GLAC SERVICE INSTRUCTION #1

**GREAT LAKES**  
AIRCRAFT COMPANY

GLAC SERVICE BULLETIN #4

# OIL COOLER SYSTEM INSTALLATION SCHEMATIC

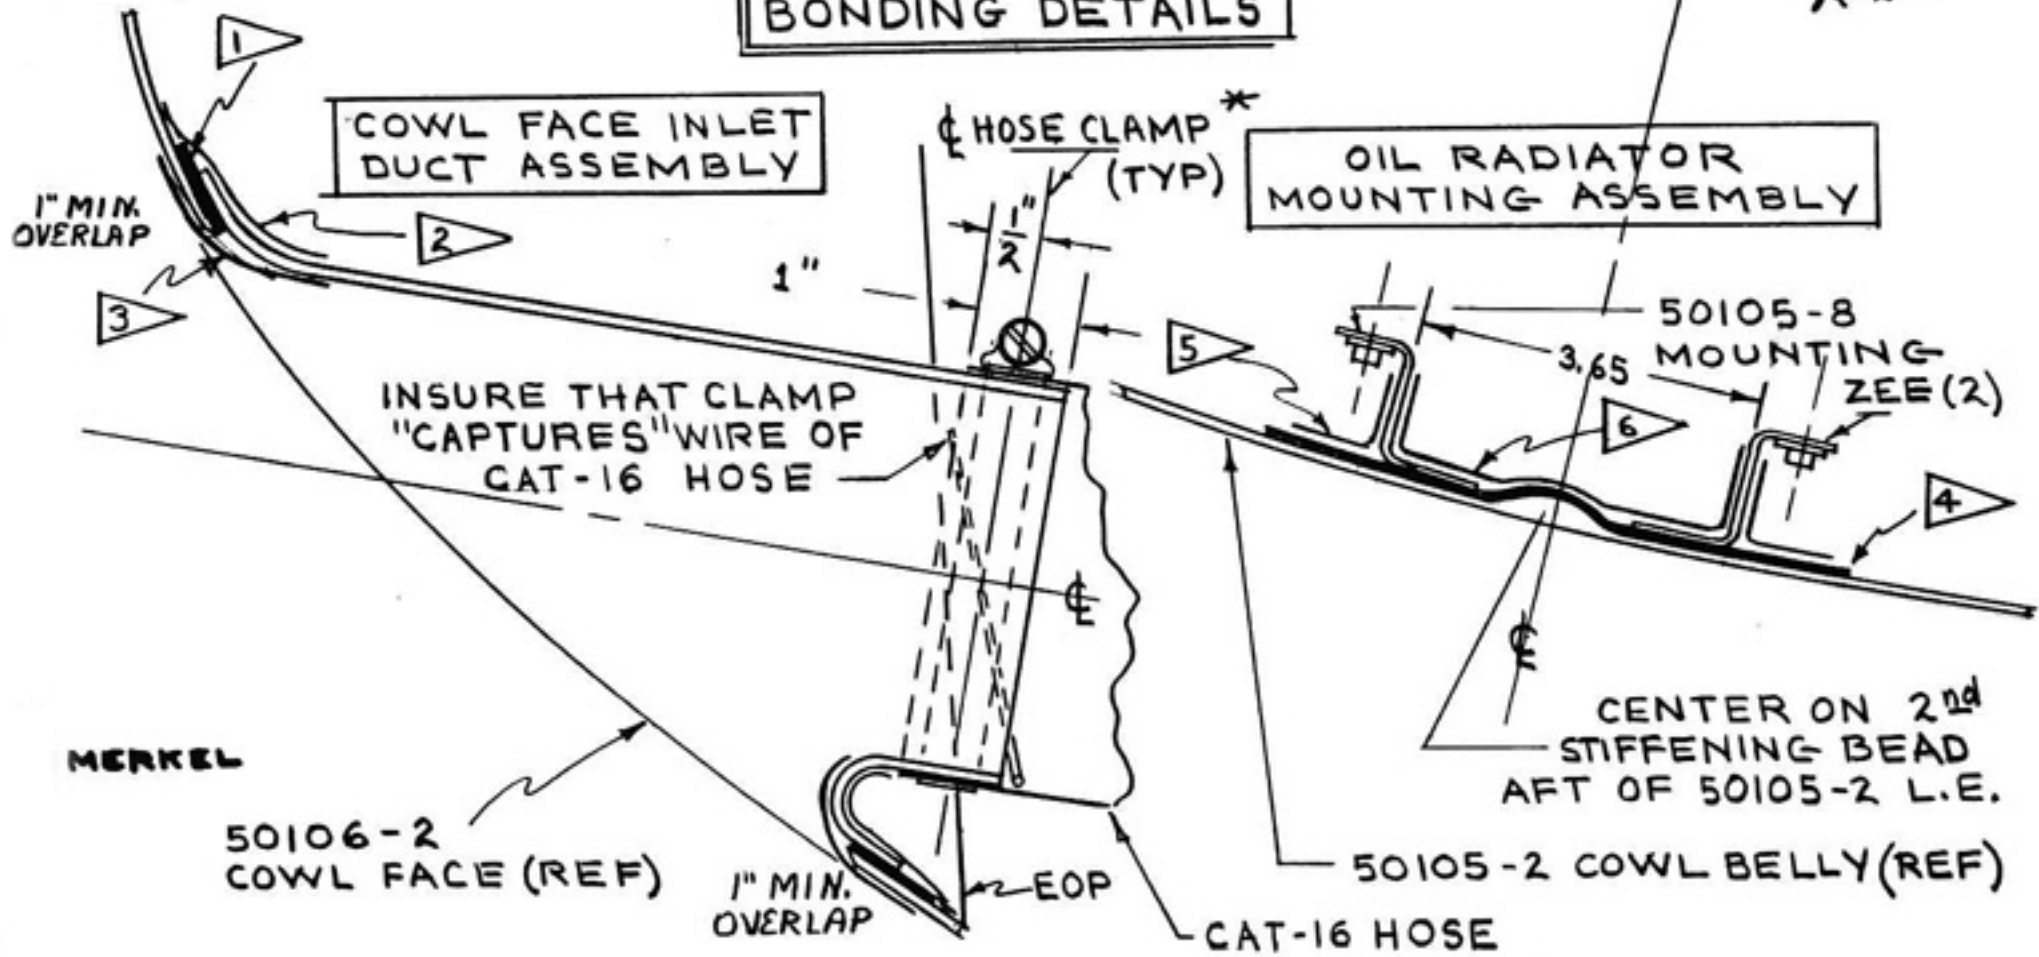
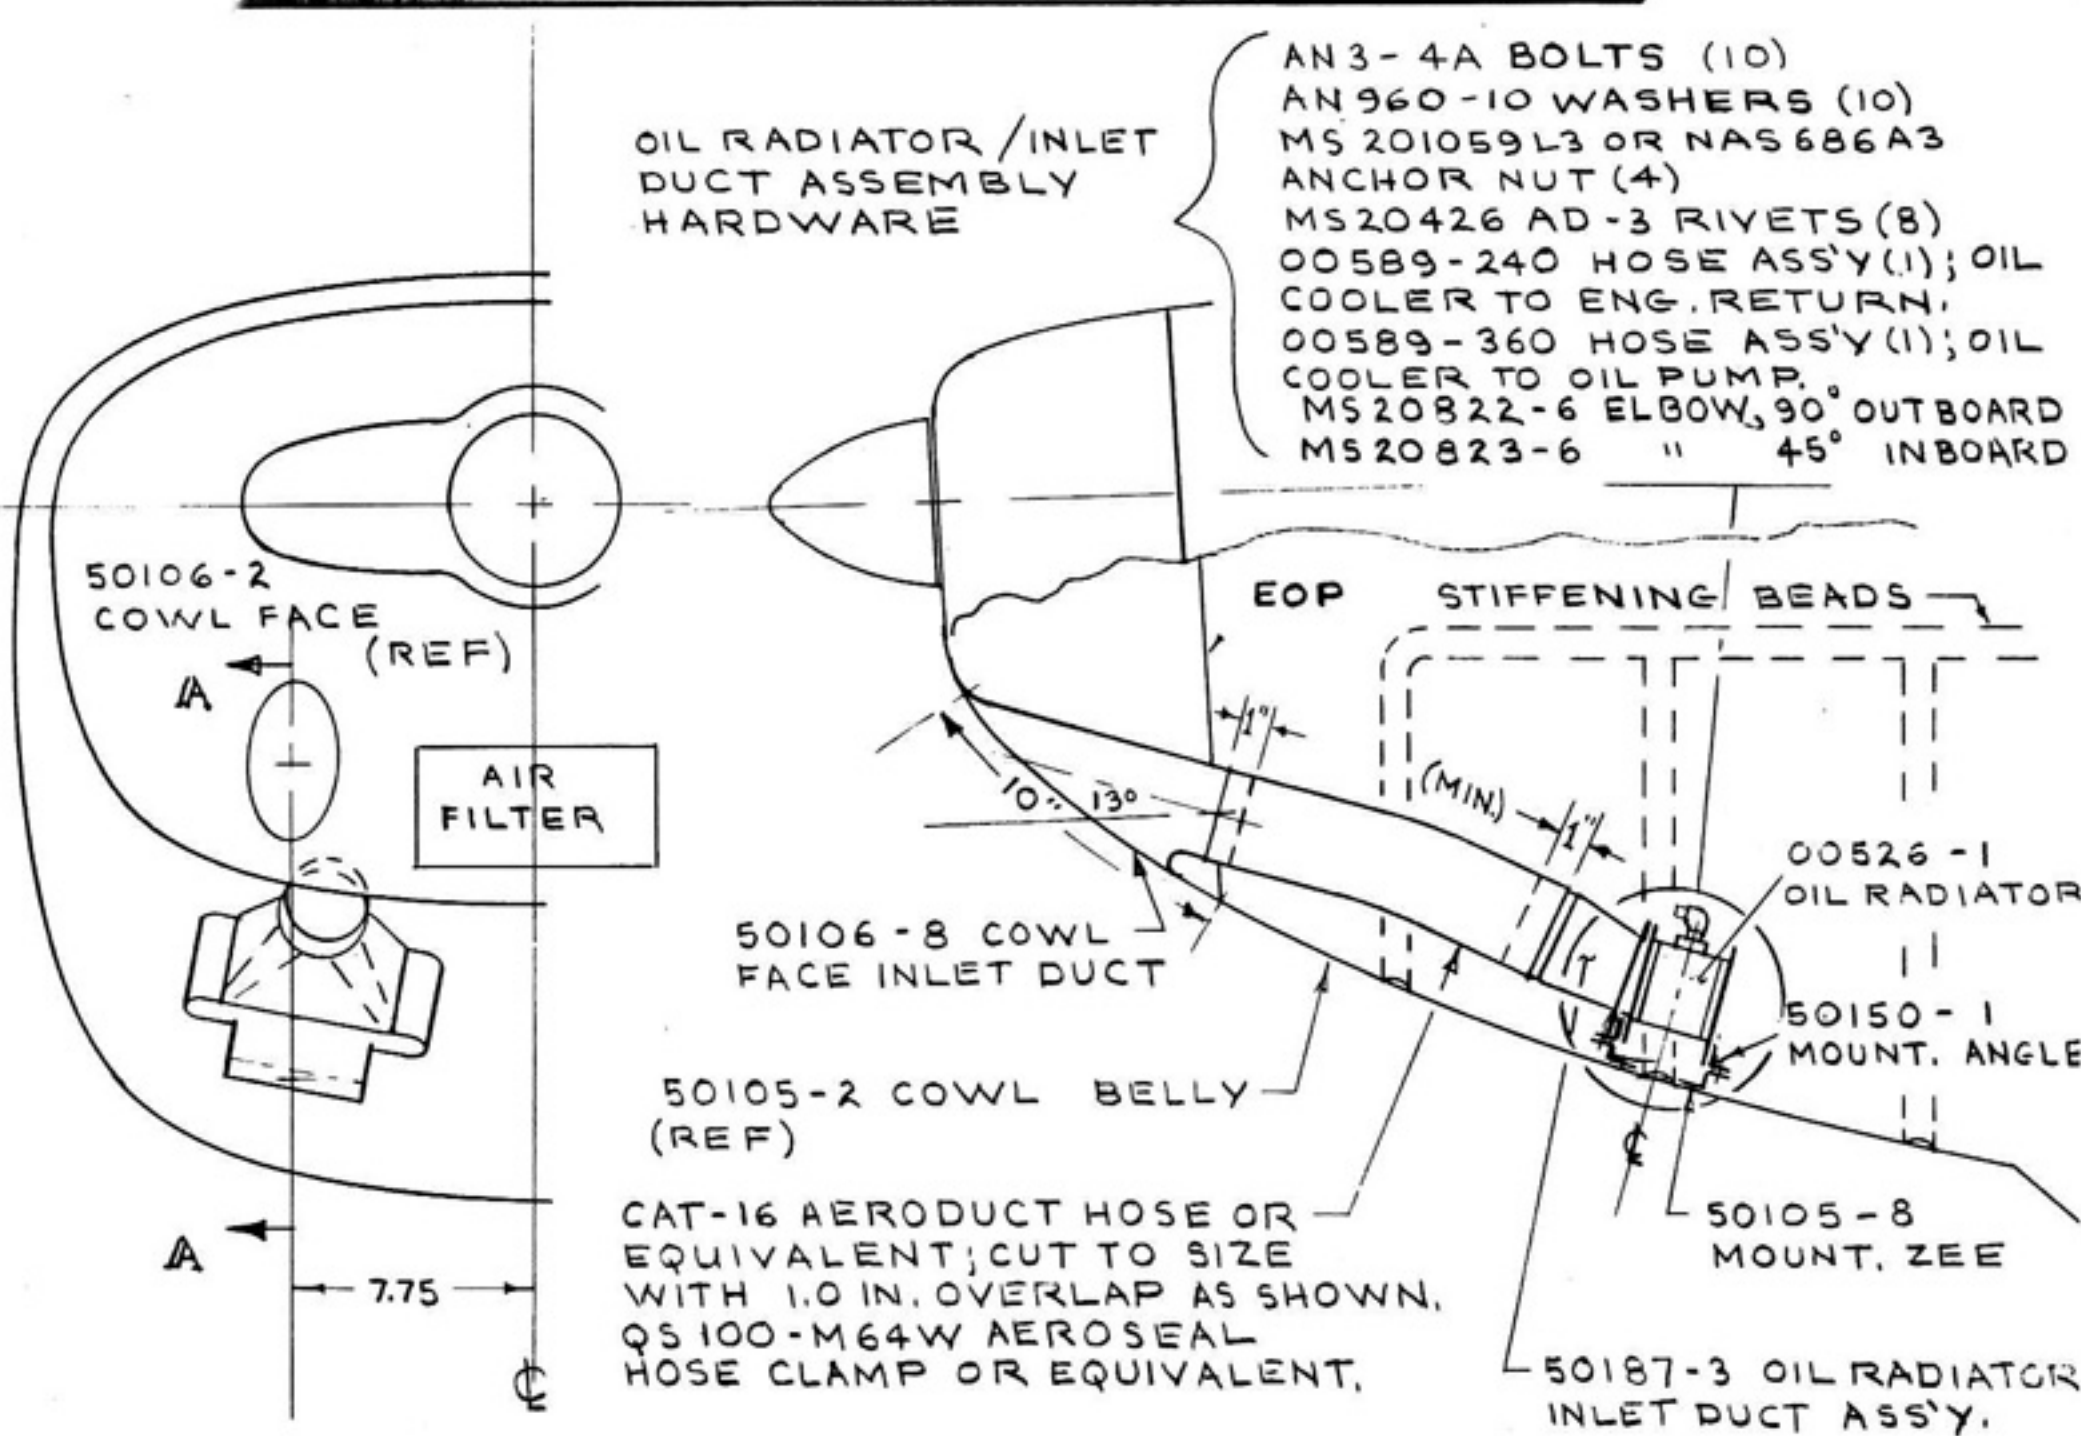
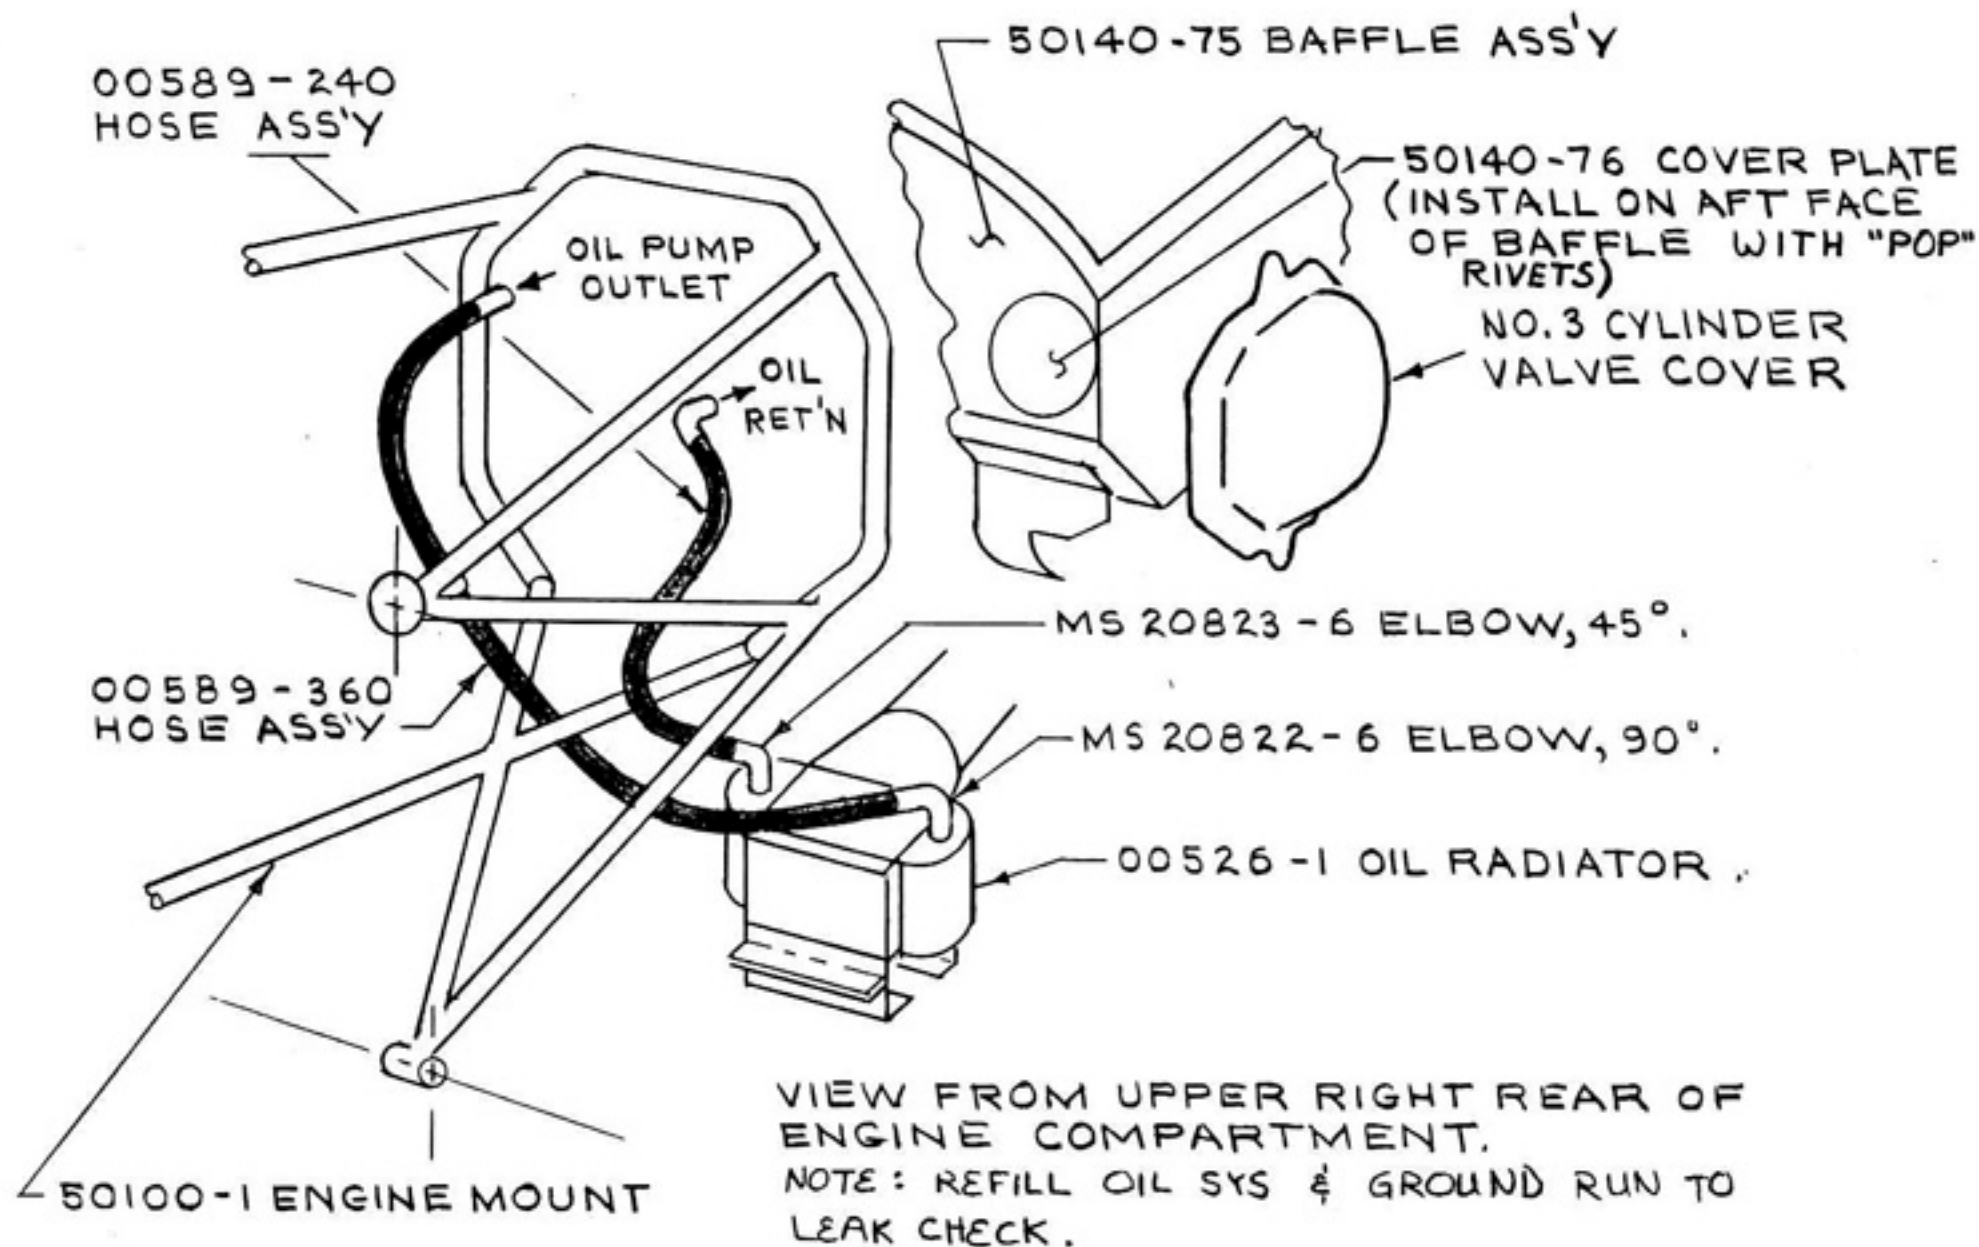
In order to provide a more effective oil cooling system for your Great Lakes Airplane, a new oil cooling system has been designed, approved by the FAA, and is now available for installation in your 2T-1A-1 or 2.

It consists of a new four inch diameter fiberglass inlet duct installed in the nose cowl to inlet ambient air through a four inch diameter hose directly into the oil cooler radiator which is remounted inside the bottom of the belly cowl.

The new oil cooling system allows the owner to use the oil radiator originally installed in the airplane. Fiberglass and paint work to the lower cowl and nose cowl will be required in order to bond the oil radiator mounts to the cowl and to install the cowl face inlet duct.

A service parts kit SPK101 is now available from the factory at our factory cost of \$249.95. This kit consists of a fiberglass inlet duct, an oil radiator inlet duct, all mounting brackets, a longer oil hose, a baffle cover plate and all the miscellaneous hardware required for the installation. Also, installation schematic diagrams and fiberglass bonding instructions are provided.

**BONDING DETAILS**

GLASS FABRIC REINFORCED POLYESTER RESIN STRUCTURAL LAMINATE PER ABOVE ILLUSTRATIONS

- 1 BED; (3) LAYERS OF 3 OZ. MATTE
- 2 LAMINATE; (4) LAYERS OF 2" 10 OZ. FIBERGLASS TAPE
- 3 LAMINATE; (1) LAYER OF 2" 10 OZ. FIBERGLASS TAPE

- 4 BED; (4) LAYERS OF 3 OZ. MATTE, 1" X 6" FORE & AFT OF STIFFENING BEAD.
- 5 LAMINATE; (3) LAYERS OF 2", 10 OZ. FIBERGLASS TAPE
- 6 LAMINATE; (4) LAYERS OF 3 OZ. MATTE

\* TORQUE TO 25 ± 5 IN-LBS.

# WEIGHT AND BALANCE

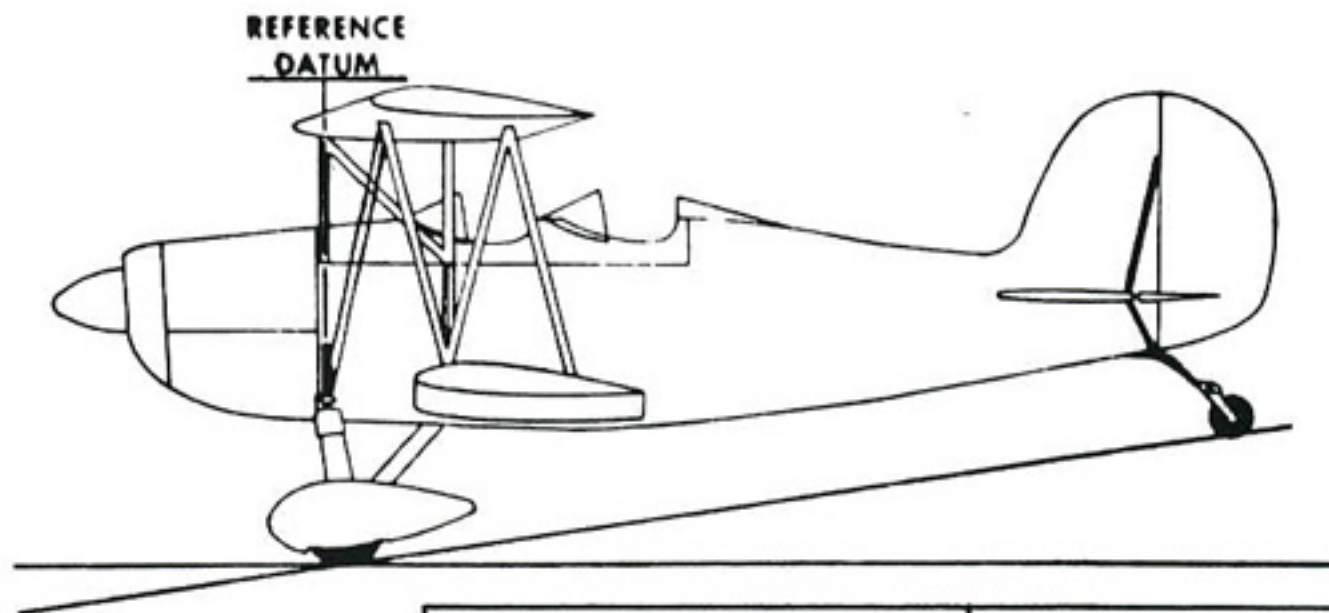
The new oil cooler installation will displace the C.G. of the airplane .070 inch forward.

# "CLEVELAND AIRCRAFT" WHEELS & BRAKES

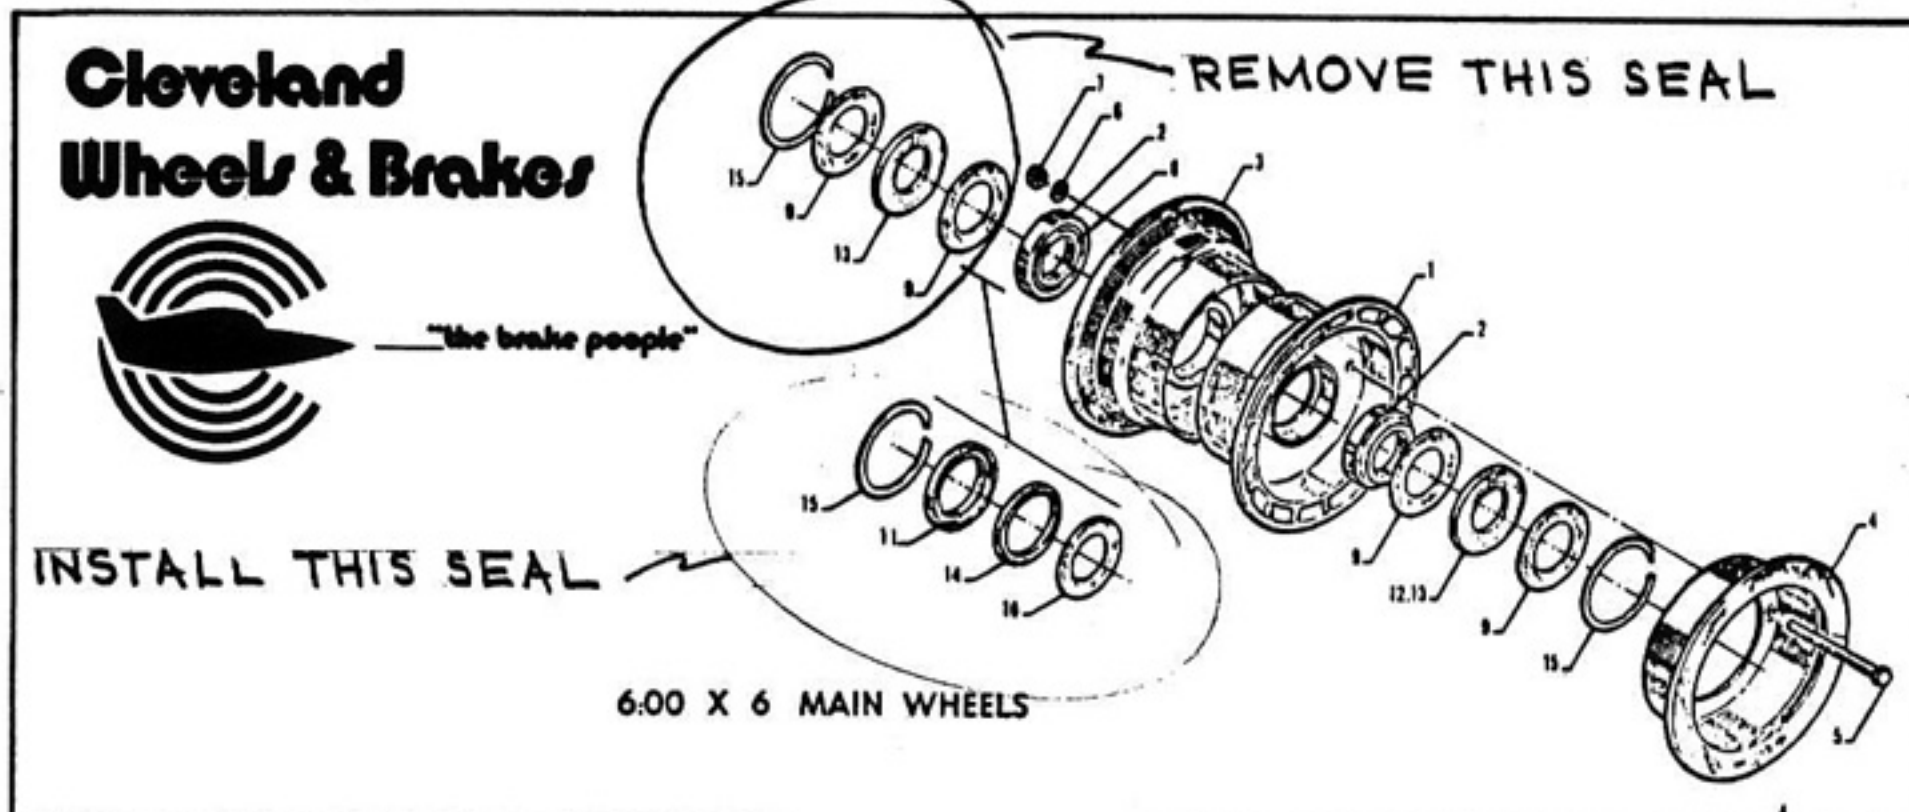
1. Remove the flat type grease seal with its respective washers and replace with a U-type (saddle) seal assembly. Cleveland part numbers as follows (see page 2):

<u>Part Number</u>	<u>Description</u>	<u>Quantity</u>
153-01500	Ring-Grease Seal	1
153-00300	Ring-Grease Seal (WASHER)	1
154-01300	Felt-Grease Seal	1
*155-00100	Snap Ring	1
